**Subject:** 110412 FAI 037 Safety Project D5 Requests Cost Proposal ASAP

**Subject:** RE: FAI-37-6.34 Preliminary Right of Way Plans (PID No. 110412)

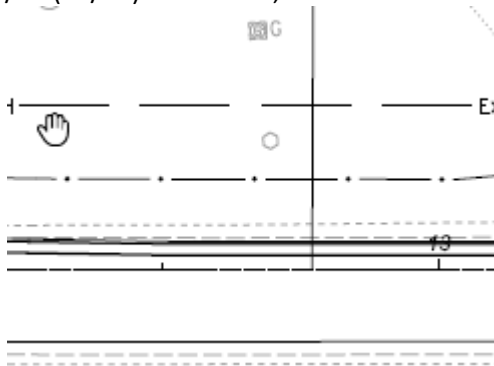
- Page 21/36 (22/37) Parcel 11-SH shows “Utility Pole Save” for private light poles. I would have them removed as ODOT will need to pay for them anyways (in take area) and would need to do a permit (not recommended) for the poles that are very close to the fence needing removed. Same Parcel has three of those poles (not 2) and also has a small sign near the fence that was not picked up on these plans:
